MILITARY SPECIFICATION

TRANSFORMER, CURRENT, TYPE D-1

Amendment-1 to
Specification MIL-T-5383 (USAF)

FIGURE 2

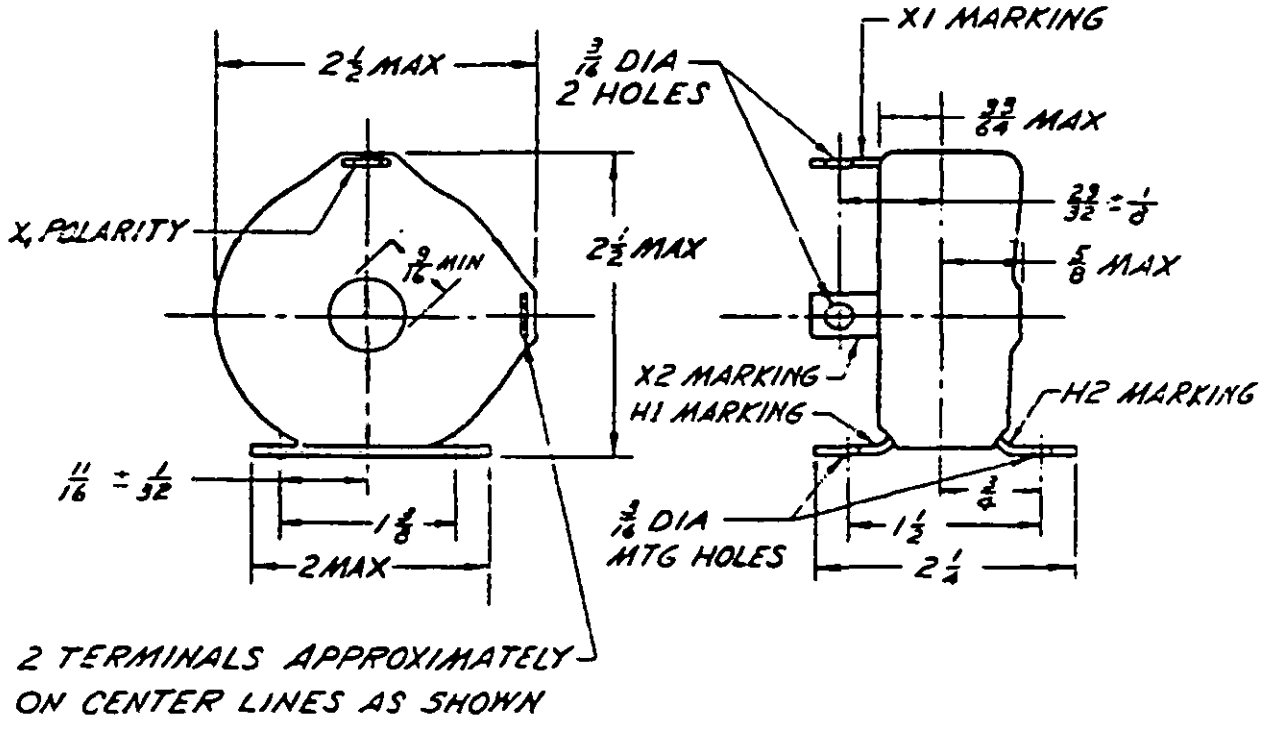
Figure 2.- Delete "Figure 2" and substitute the attached Figure 2. Figure 2 forms page 2 of this amendment.
